CITY OF LA VISTA
MAYOR AND CITY COUNCIL REPORT
APRIL 4, 2017 AGENDA

Subject:	Type:	Submitted By:
APPLICATION FOR WAIVER, REVISED PRELIMINARY PLAT, FINAL PLAT, SUBDIVISION AGREEMENT, PUD SITE PLAN & CUP FOR AN AUTOMOBILE DEALERSHIP – TAX LOT 4 EXC S 1551.37 FT & EXC ROW 23-14-11 (SW OF 144 TH & GILES ROAD)	◆ RESOLUTIONS (5) ORDINANCE RECEIVE/FILE	ANN BIRCH COMMUNITY DEVELOPMENT DIRECTOR

RE: Revised Preliminary Plat and Final Plat – Initial Review
Woodhouse Place

RE: Revised Planned Unit Development (PUD) Site Plan and Conditional Use Permit (CUP) – Initial Review
Woodhouse Place

Planned Unit Development (PUD)

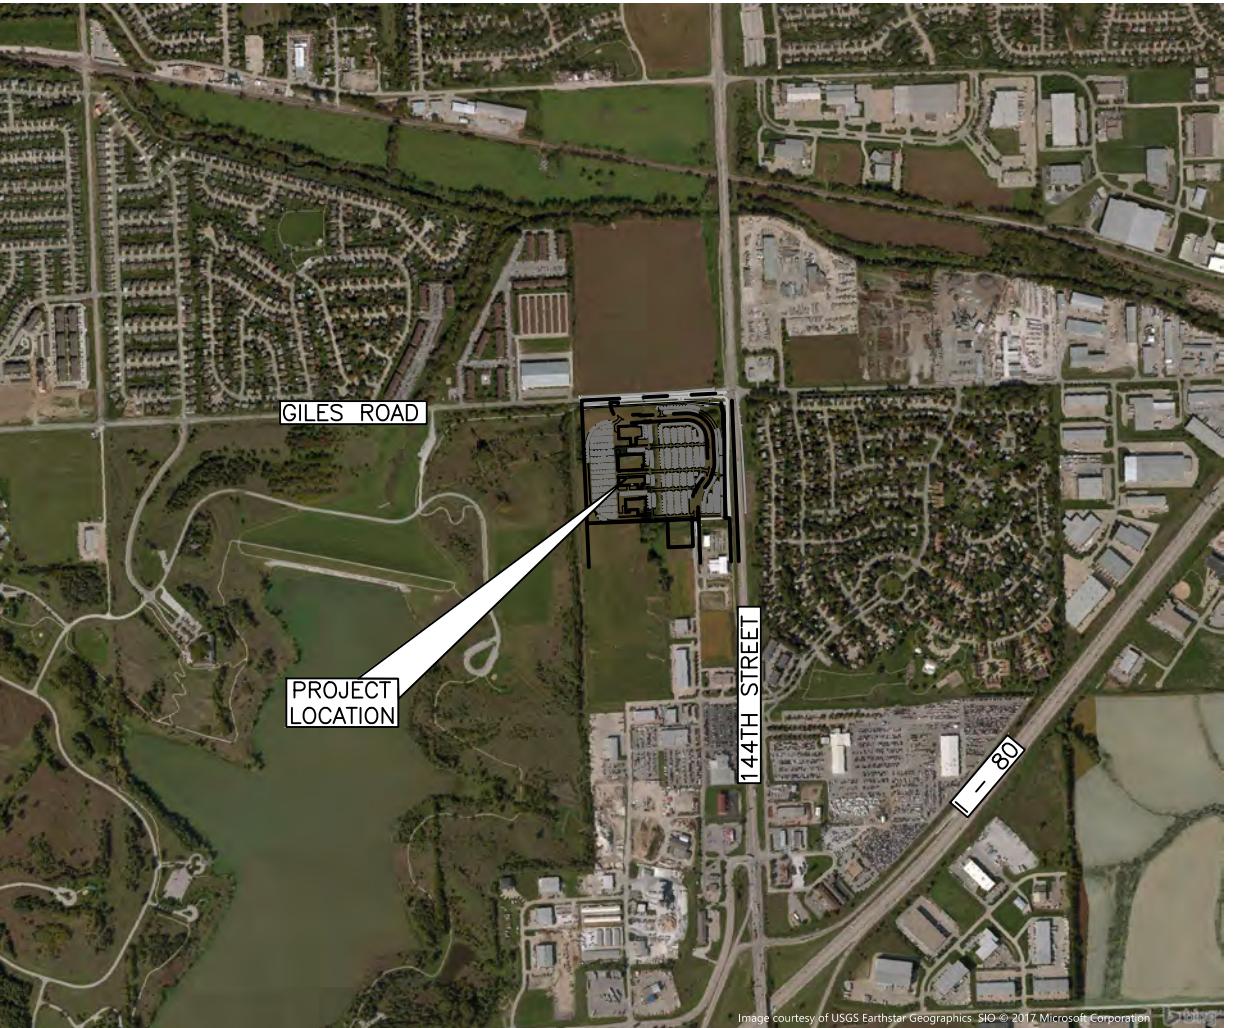
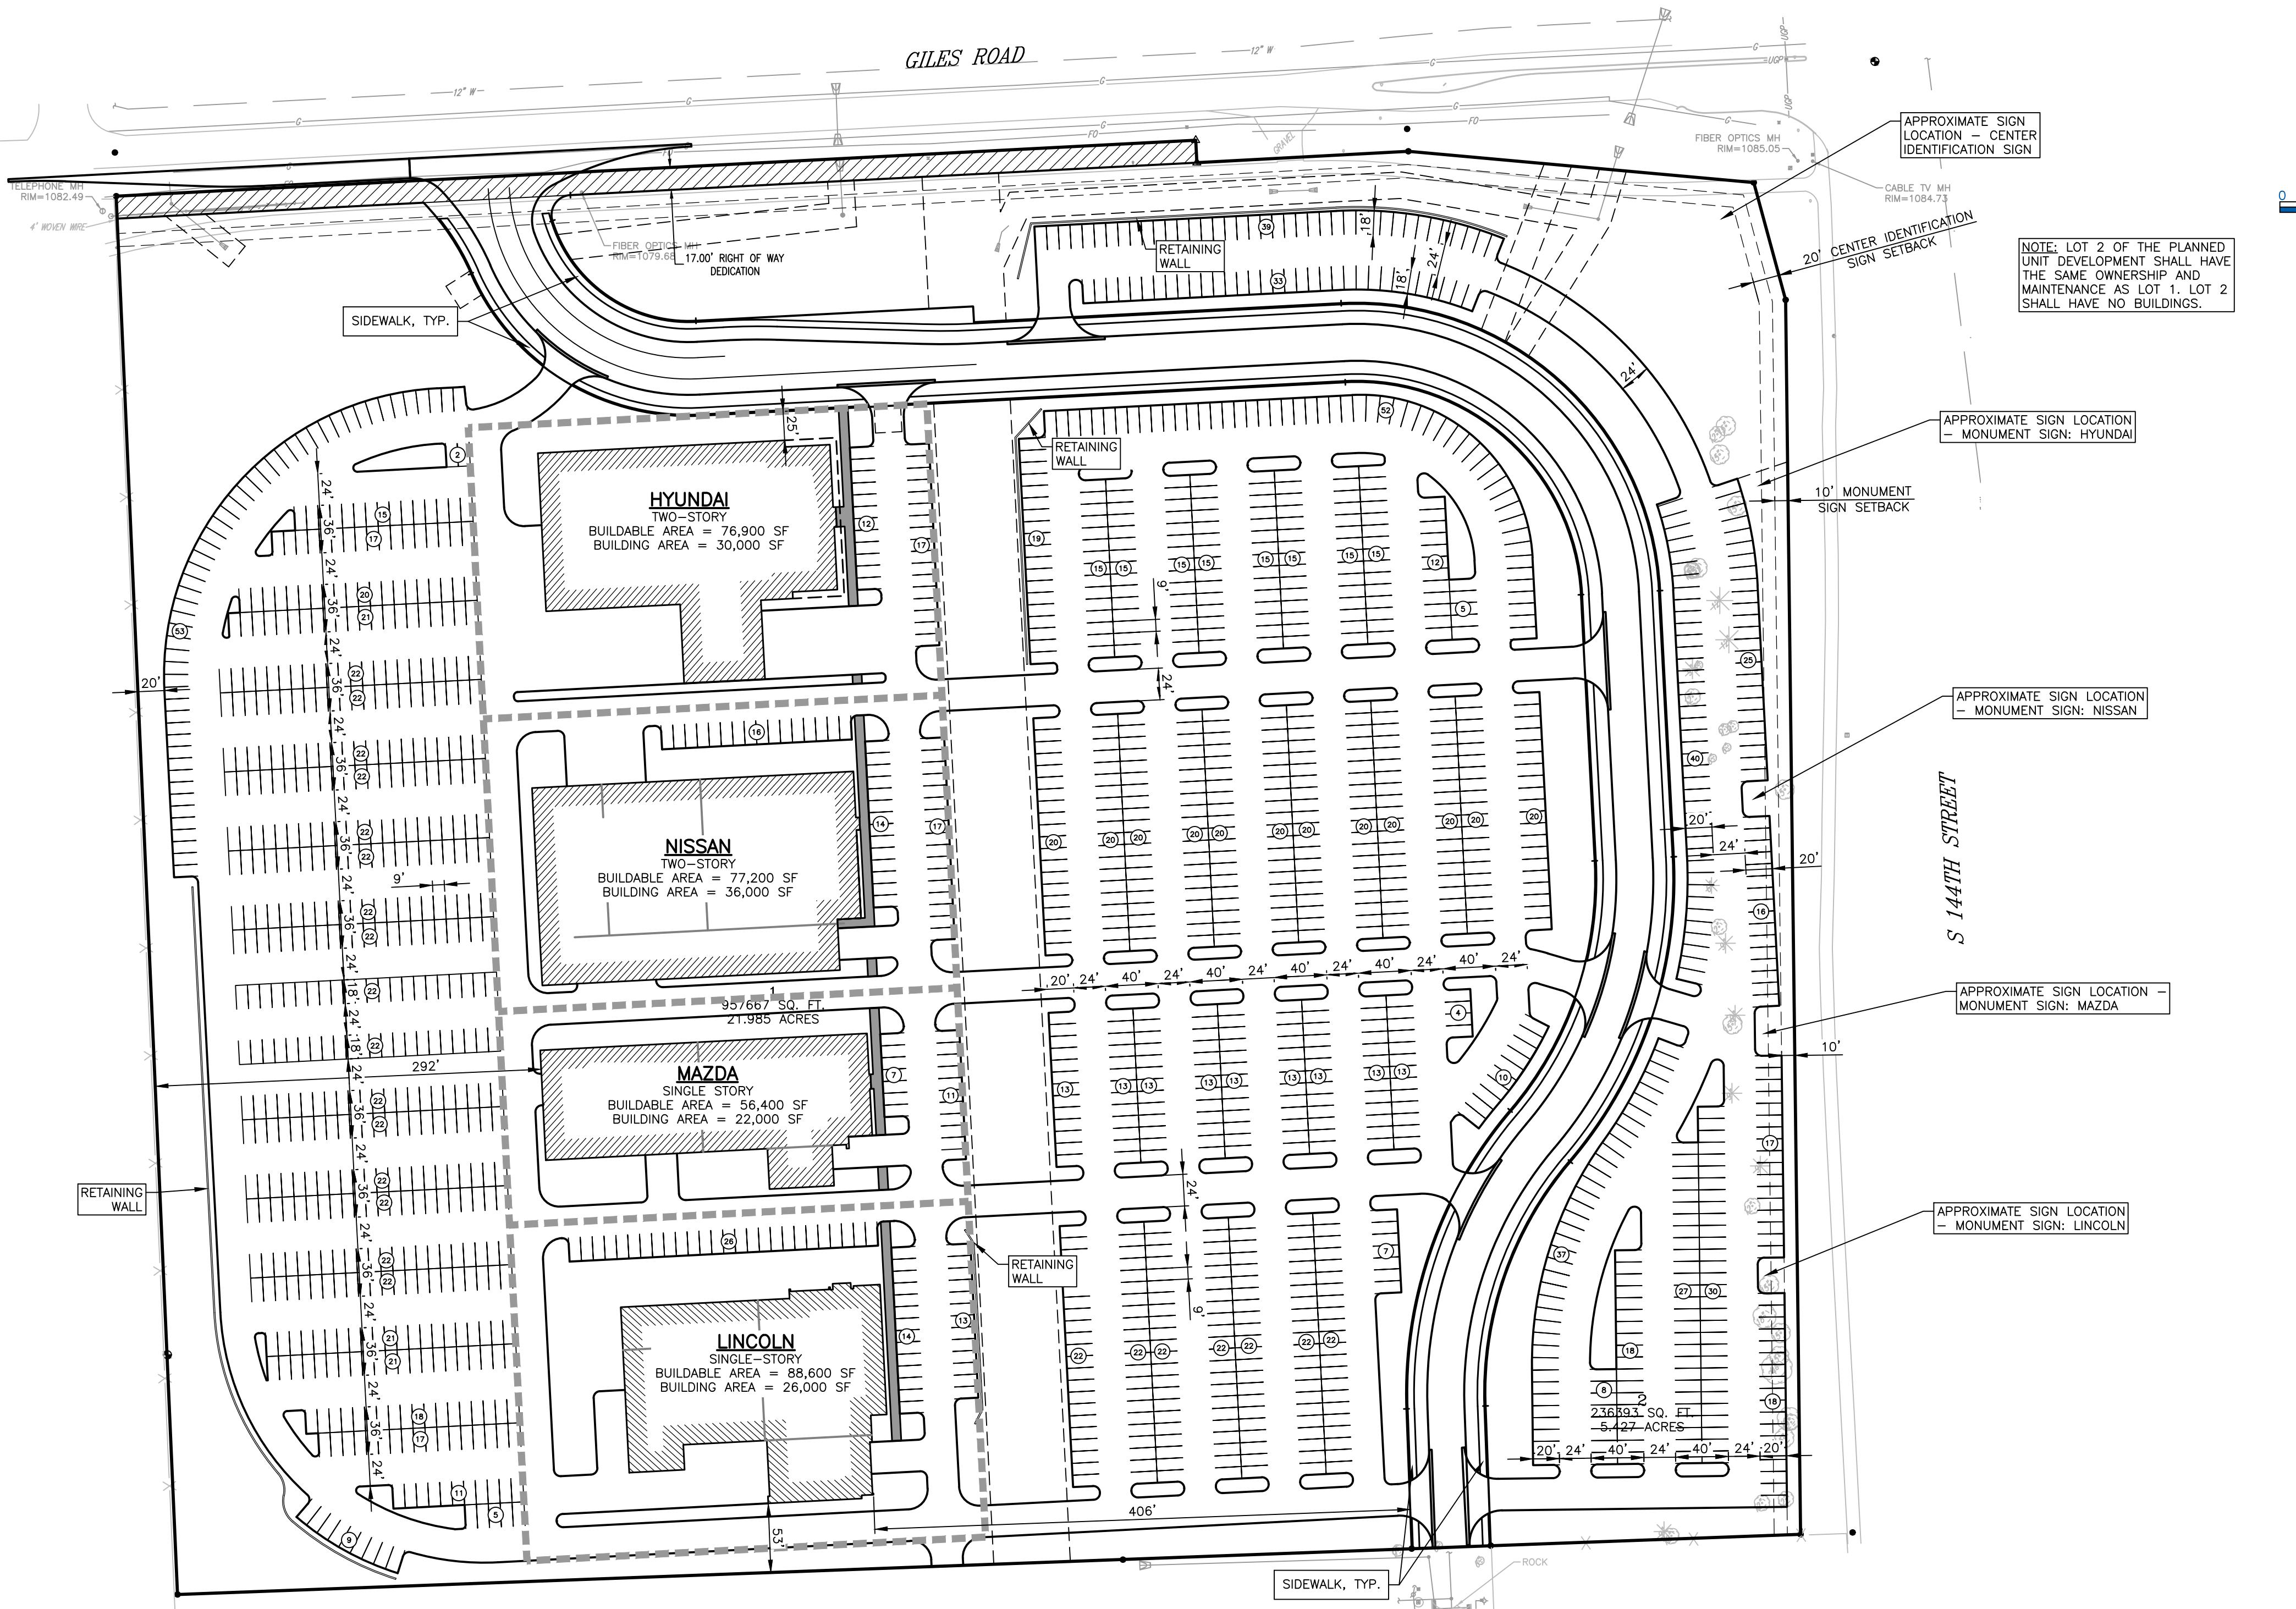
1. In regards to Article 5.15.04.01 the applicant needs to submit a proposed schedule of construction.
2. The PUD Site Plan lists the zoning as C-3. However the zoning is C-3 with a Gateway Corridor District overlay.

3. In five locations, the PUD Site Plan notes "approximate sign locations". However, the approximate locations appear to be somewhere within the minimum setbacks for monument signs. Clarity on the proposed setback of the signage of the monument signs needs to be added to the site plan.

4. The northernmost note for the approximate sign location has been discussed to be a "Center Identification Sign", the site plan needs to be noted as such. Also, there should be enough room for this sign to meet required setbacks.

5. The remaining four sign locations are believed to be a single-tenant "Monument Sign" design. Please note the site plan with this designation. Each sign should be tied back to their corresponding building through a notation on the site plan.

14. Identify by notation on the PUD Site Plan that sidewalks are proposed to be constructed along 145th Street.
15. In regards to Article 5.15.05.02(4), consideration should be given to sidewalks that connect the buildings to the proposed public sidewalks and the hiking/biking trail.

16. A vicinity map needs to be added to the PUD Site Plan to meet the requirements of Article 5.15.05.06
17. In regards to Article 5.15.05.07, a design guideline for Woodhouse Place has been drafted and will be forwarded after the conclusion of the Design Review Architect's finalization of edits. This guideline will be adopted for the development through the PUD Ordinance and will guide the final design review of the buildings after approval of the plat, PUD and CUP.

REVISED PRELIMINARY PLAT
DRAINAGE MAP/PCSMP

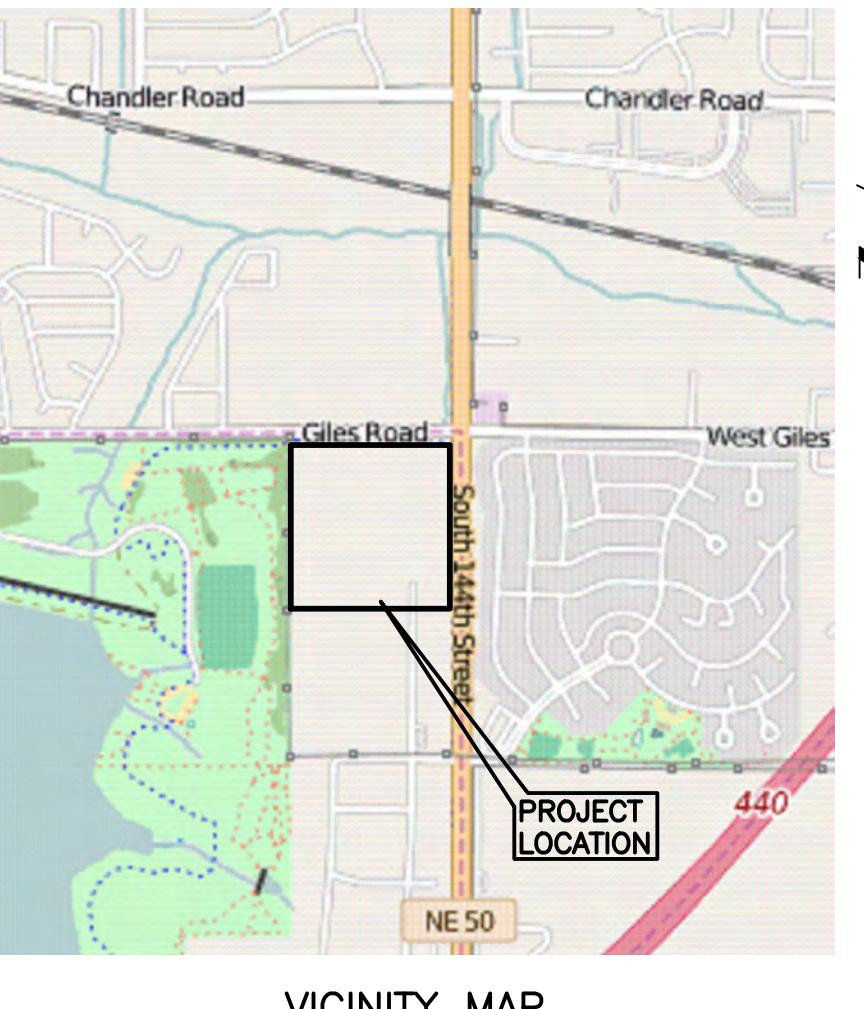
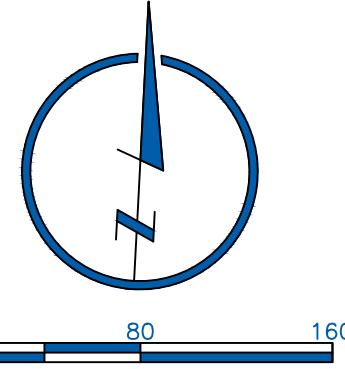
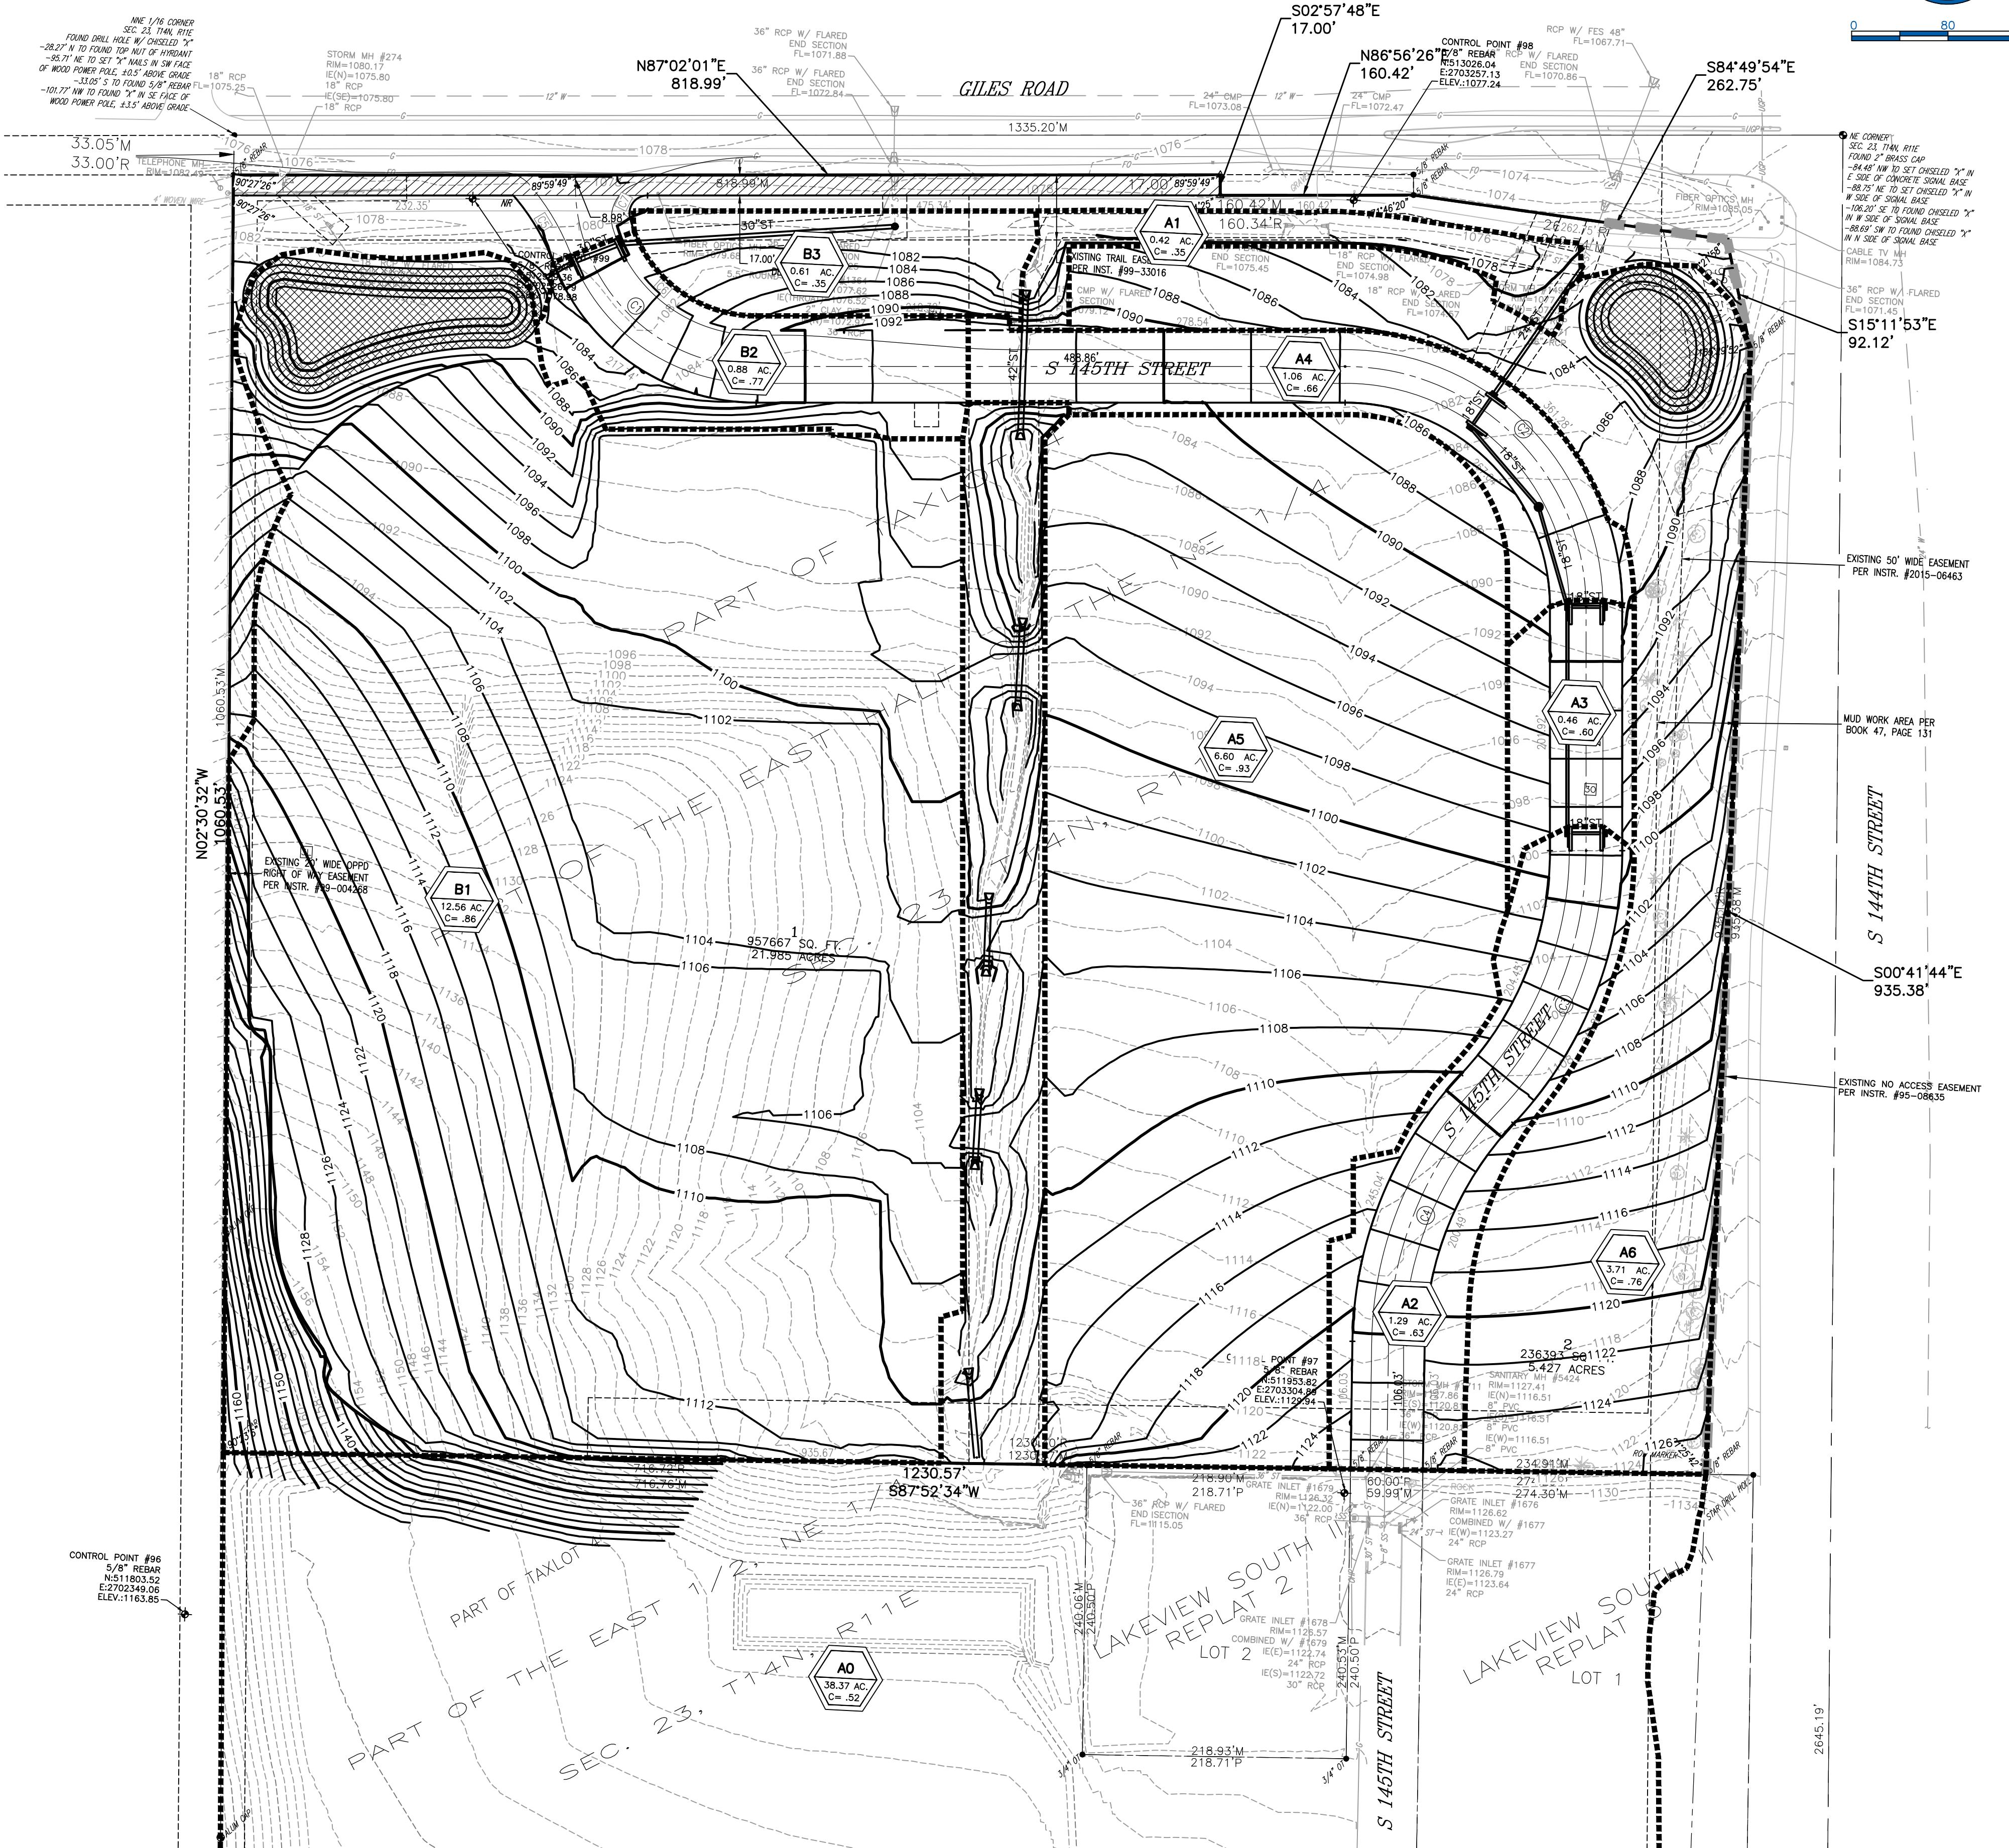
- a. **Comment:** The drainage study needs to address no increase in peak runoffs for 2-year frequency storm events per the Papillion Creek Watershed Partnership policies. This includes drainage areas for proposed public streets.

b. **Comment:** The study needs to identify the Giles Road culvert capacity limitations. The drainage map and capacity calculations to these existing culverts need to be obtained from Sarpy County Public Works and included in the study as an appendix.

c. **Comment:** Provisions for $\frac{1}{2}$ -inch water quality treatment from public street pavement will need to be addressed. This might include a diversion of low flows from the public storm sewers into the water quality basins or some other solution.

f. **Comment:** In the first table under the Water Quality Treatment section the basins to Pond A should be A1 through A5 unless an alternative method is proposed.

g. **Comment:** Water quality treatment for area B1 needs to be provided.

h. **Comment:** In the second table under the Water Quality Treatment section the Pond A outlet flow for 2-year storms is too high and must be less than the pre- development conditions.

i. **Comment:** In Section C-Hydraflow Analysis it indicates no net increase for each storm event which does not seem to be the case from the calculations presented. Clarify as required.

Response: The drainage study has been revised to illustrate the restriction of peak flow during the 2-year frequency storm. Although runoff routed to public streets bypasses the water quality ponds, the ponds were oversized to provide excess storage which allows for the overall flow offsite to be restricted to a point below the historical peak flow.

Response: The revised drainage study includes several pages from the Giles Road improvements drainage study that indicate that the Woodhouse Place project is restricting peak flows below the existing culvert capacity.

Response: Based on discussion with the City Engineer John Kottmann the $\frac{1}{2}$ -inch water quality treatment from public right-of-way may bypass the water quality ponds, if the ponds are shown to treat additional volume equal to the required right-of-way volume. As discussed, this is similar to how other jurisdictions handle the water quality for public right-of-way. The water quality ponds have been oversized to provide sufficient water quality treatment volumes for the entire disturbed area. This includes drainage areas that bypass the ponds.

Response: Agreed. The table has been modified to identify the drainage areas correctly.

Response: The water quality ponds have been oversized to provide sufficient water quality treatment volumes for the entire disturbed area. This includes drainage areas that bypass the ponds.

Response: The drainage study has been revised to illustrate the restriction of peak flow during the 2-year frequency storm.

Response: Agreed. The drainage study has been revised to clarify that there is a no-net increase for the 2-year storm.
